City of Laurinburg North Fire Station
Project No.: 2021-062
Issue to: Bidders

City of Laurinburg, Owner
Contract Document Date: September 15, 2021
Addendum Date: December 13, 2021

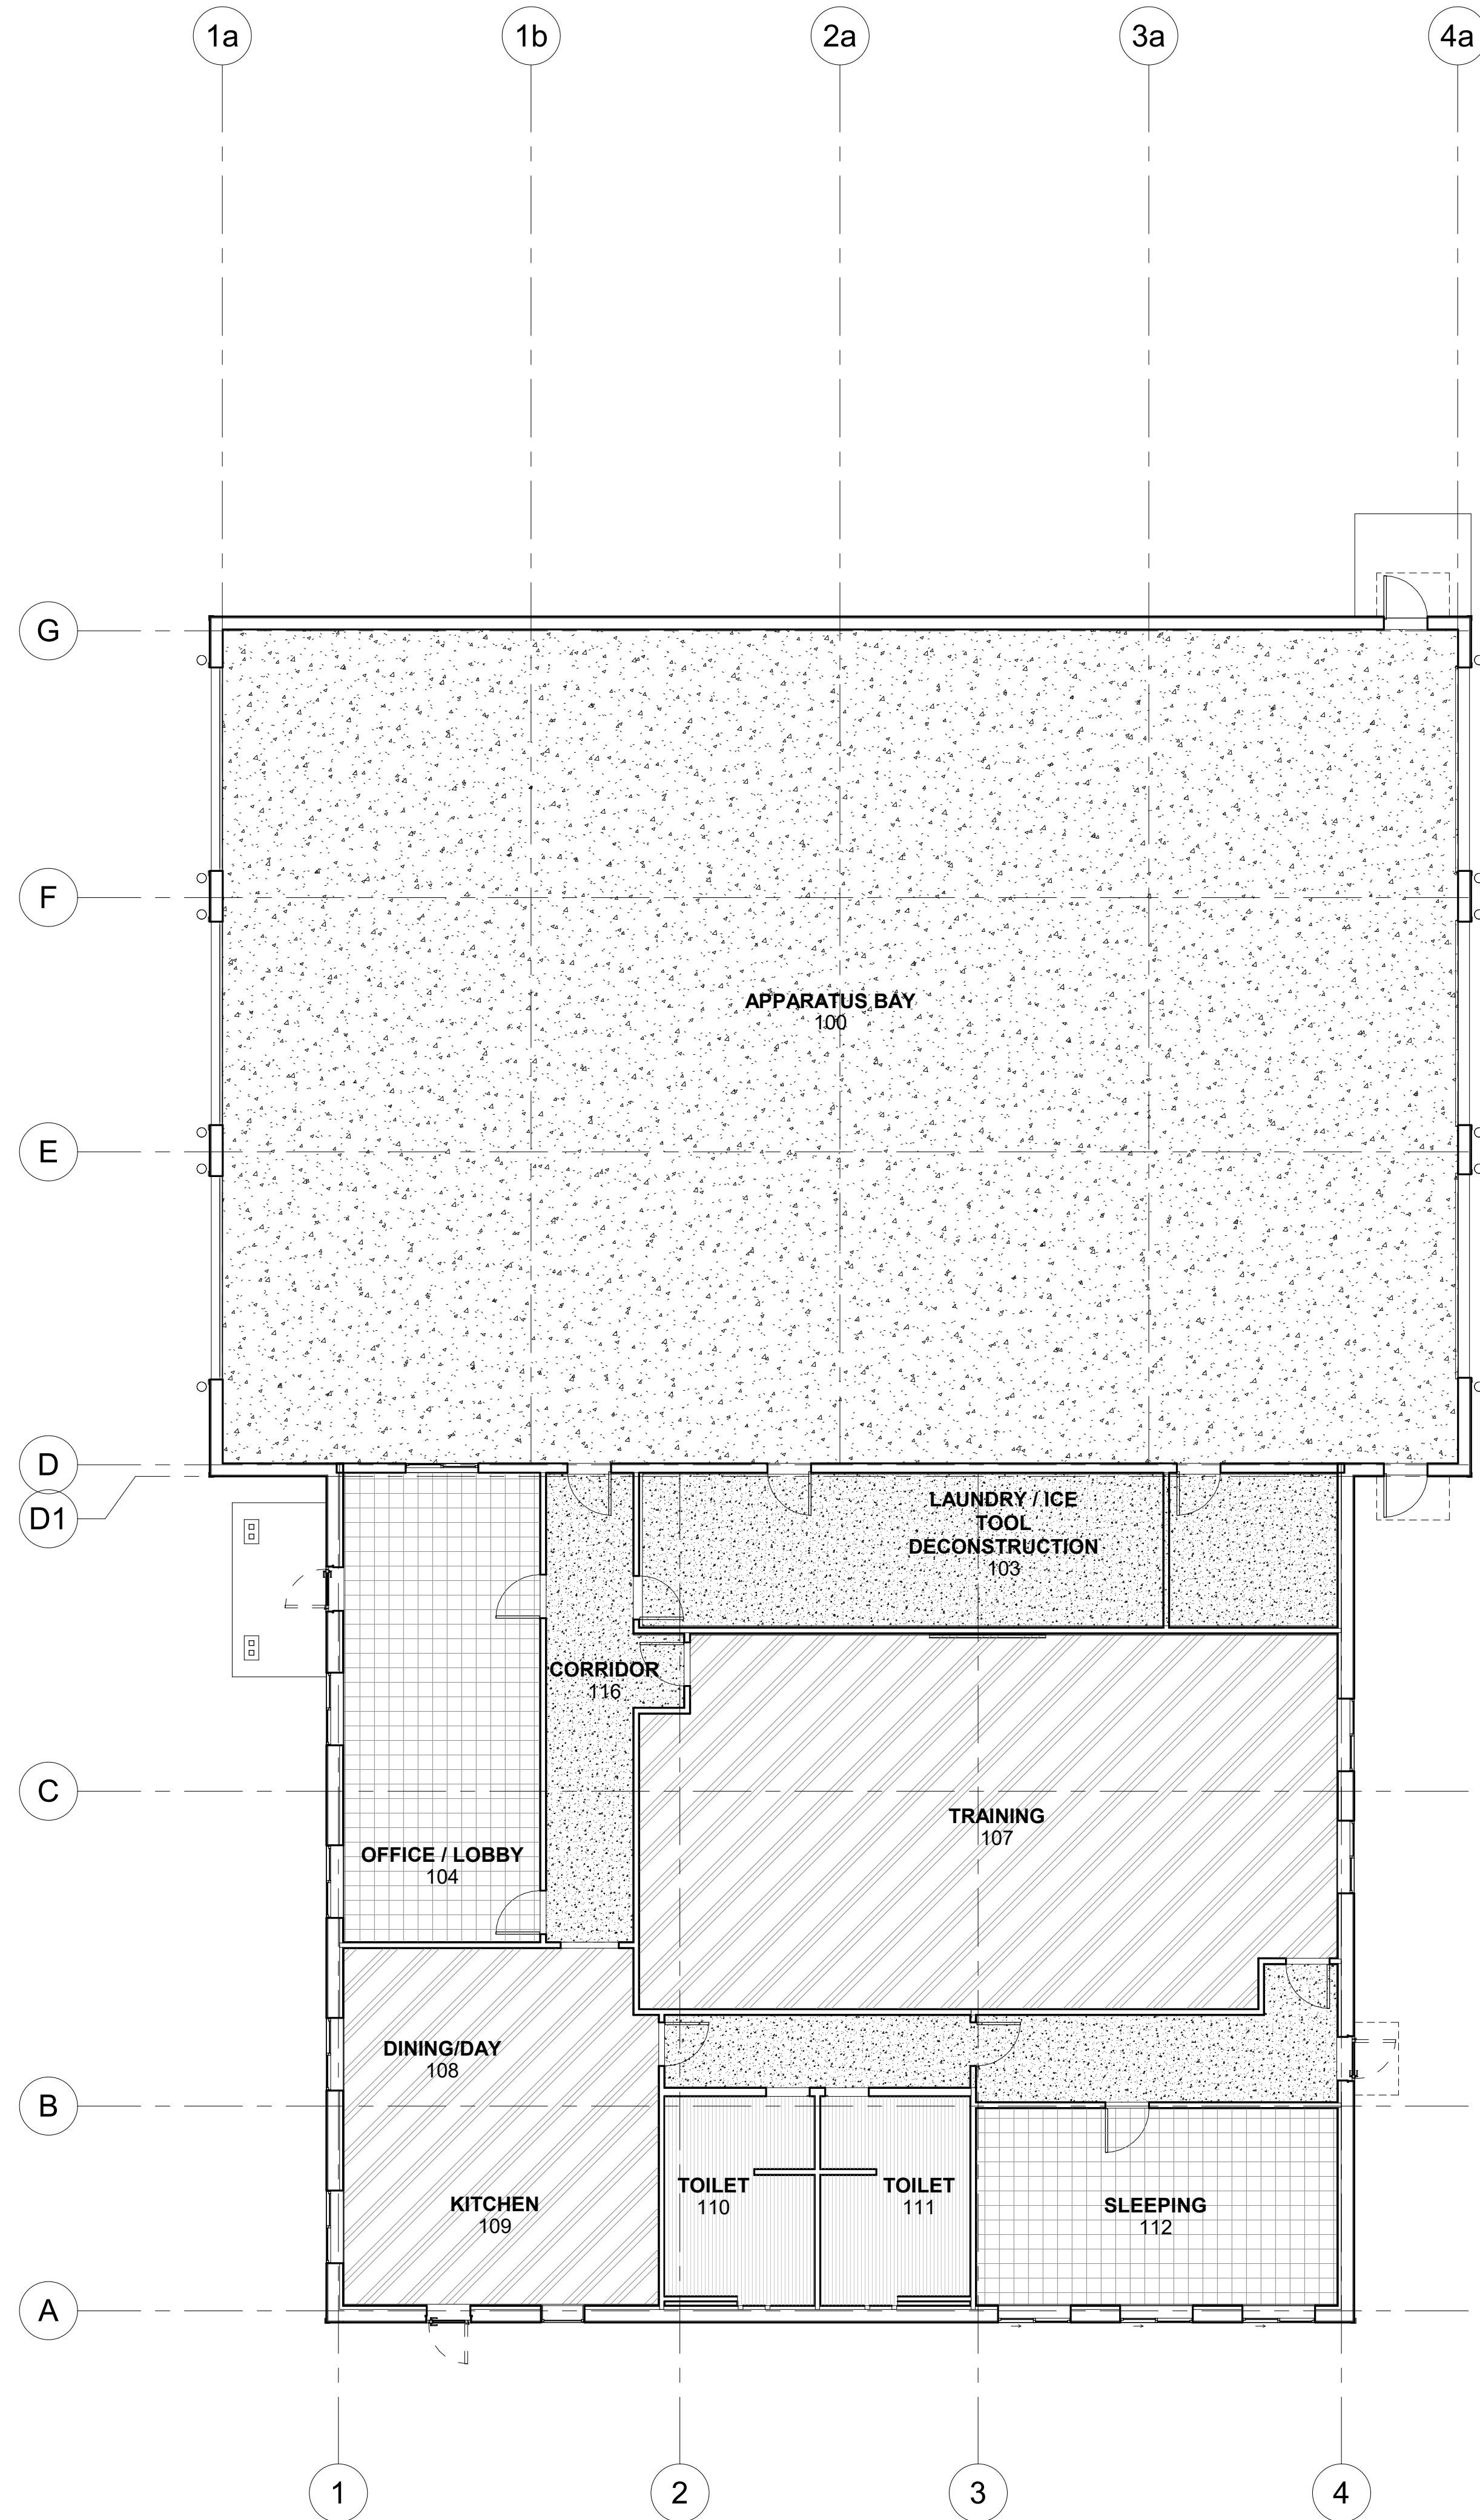
- 1.7 Drawing A10.21 – FINISH PLAN, LEGEND, NOTES, & SCHEDULE
- 1.8 Drawing A30.21 – ALTERNATE FINISH PLAN, LEGEND, NOTES, & SCHEDULE
